**RE: Palen Solar Power Project, Docket No. 09-AFC-7**  
*Responses to CEC Request for Information*

## **Responses to Clarification Request by Susan Sanders per email dated 8/3/2010, 10:37AM:**

**Figure 7  
Proposed Project Special  
Status Plant Species**

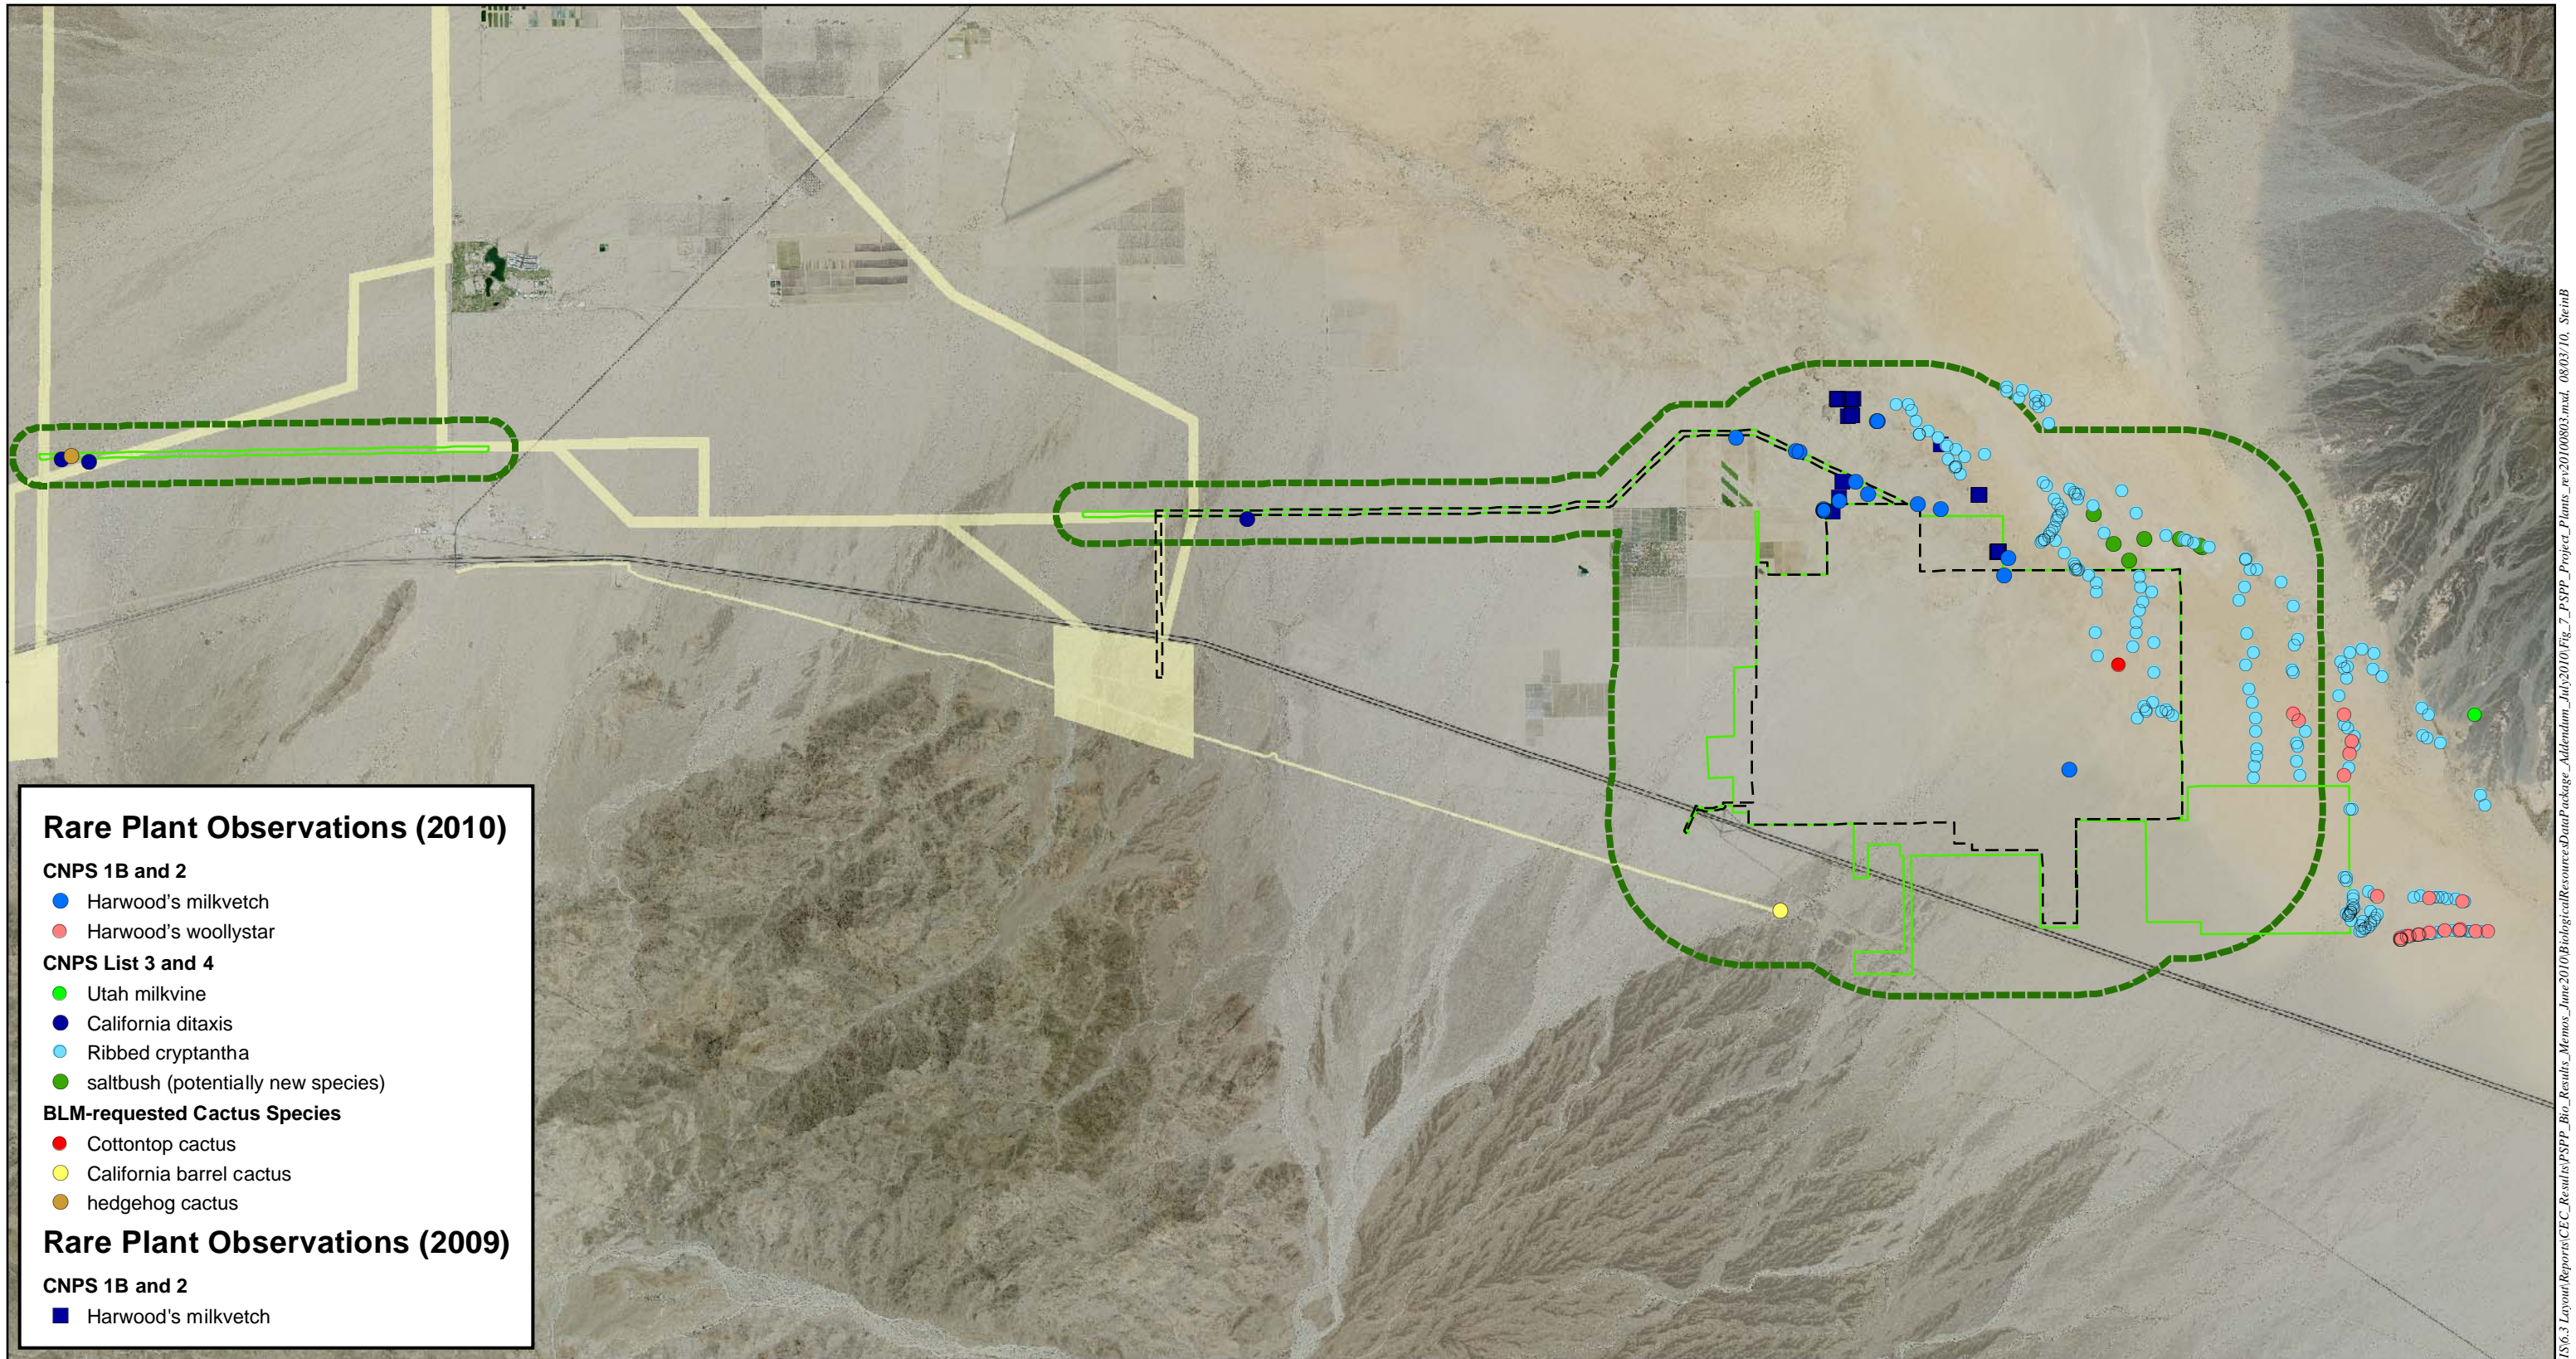
- 7) California ditaxis – Table 3 of the Biological Resources Data Package Addendum indicates that California ditaxis was found during spring 2010 surveys yet Figure 7 does not show their locations. Please confirm that this species was found and their locations.

See the revised Figure 7 attached which clarifies the locations of the California ditaxis.
